U.S. Department of the Interior
Bureau of Land Management

Buffalo Field Office

Wyodak Coal Bed Methane Project Final Environmental Impact Statement

This FEIS is published in abbreviated format. Reviewers will need the WYODAK Coal Bed Methane Project Draft Environmental Impact Statement (DEIS), BLM, May 1999, for review of the complete EIS.

Figure 1

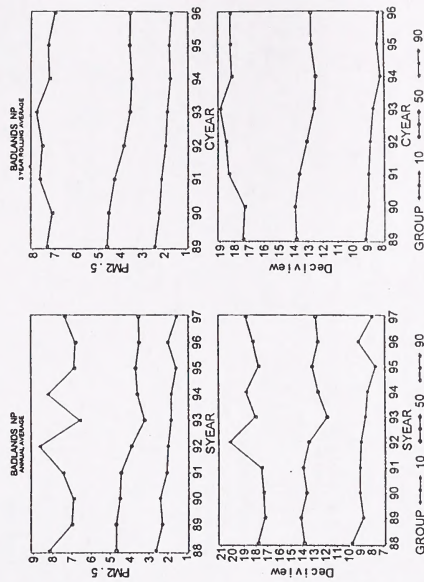
Of the Class I/Class II areas identified, only one (Badlands) has an aerosol/visibility monitoring record. Data collection began at the Badlands Class I area in 1988. Figure 1 depicts PM₁₀ (fine particulate) concentration and visibility at the Badlands monitoring site. The graph was obtained from the IMPROVE network database maintained by Colorado State University. The graphs are depicted in a single year (5-year) and cumulative year (3-year rolling average). The graphs show that the best visibility days (Group 10) have been steadily improving

Figure 2

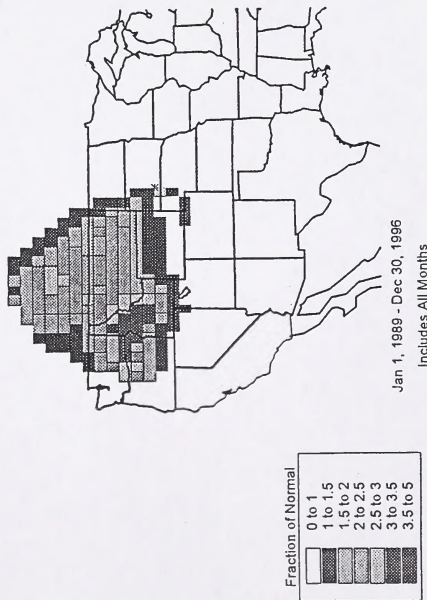
The National Park Service has developed graphics that show the source of "visibility impairing emissions to the Badlands Class I Area (Figure 2). While the PRB is included on this figure, the source of emissions includes much of the northwestern U.S. and portions of Canada. The graphic recognizes that visibility impairment is a regional issue and that the depiction of impacts solely from the PRB is meaningless.

The bottom line is that the discussion of visibility impacts from the PRB is very questionable, and irrelevant under the current regulatory framework (see the following discussion). **This should be clearly noted in the FEIS.**

Figure 3

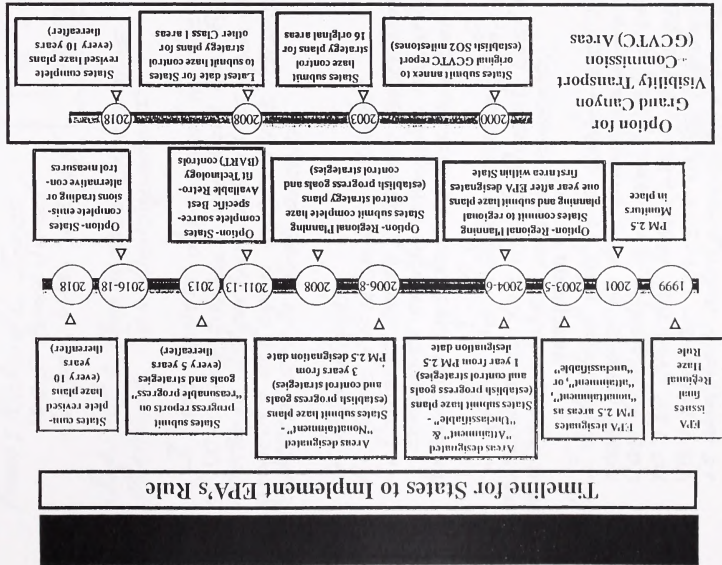
State Implementation Plans (SIPs) are due under the RHP in the 2003-2008 time period. Refer to Figure 3 for the State Implementation Timeline. These SIPs must detail how emissions will be managed in order to achieve steady and continuous improvement in visibility in the Class I Areas. A copy of the Regional Haze Rule is attached, as well as a graphical depiction of the implementation schedule.

The FEIS needs to clearly acknowledge this newly promulgated program, and recognize that there is a program and process in place to manage visibility. The reader cannot be left with the impression that visibility will necessarily be impacted by economic growth in the PRB, and that development can be managed in conjunction with visibility concerns throughout the region. The FEIS and the Record of Decision should contain NO specific mitigation requirements relative to visibility, as this type of action would pre-suppose the outcome of the required State Implementation Plan developed under the Regional Haze program. The FEIS also needs to conclude that the visibility impacts discussed in the DEIS are WORST CASE.
